L&V Checklist

Landscape and Visual Impact Assessment Checklist for Site Audit – North Point PTW

Inspection Date: 18 May, 2022
Time: 10:30 am

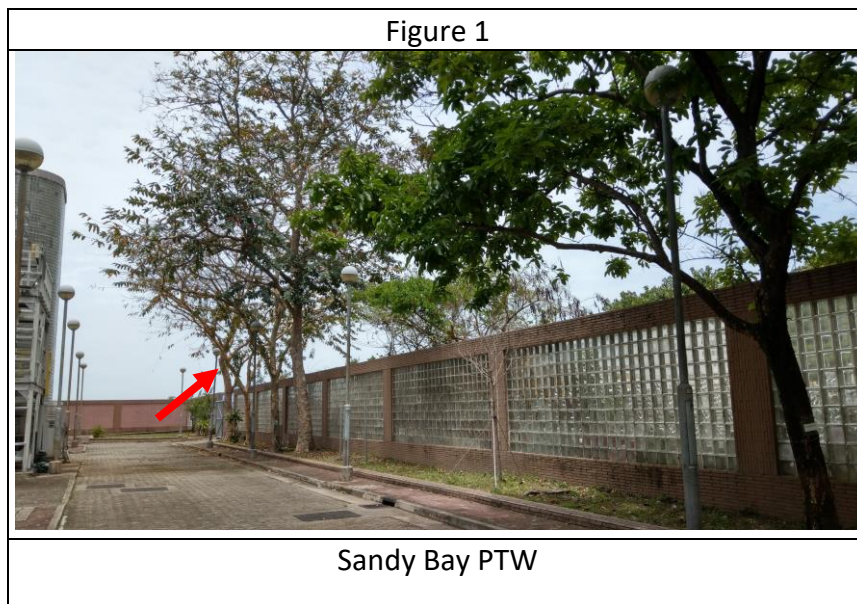
- Contractor was reminded to carry out proper maintenance to plantings and recommended to increase the frequency of watering.
- It was noted that leaves shredded and foliage's colour turns yellow for trees at inner side as shown in Figure 1. Continuous monitoring of the tree condition is required.
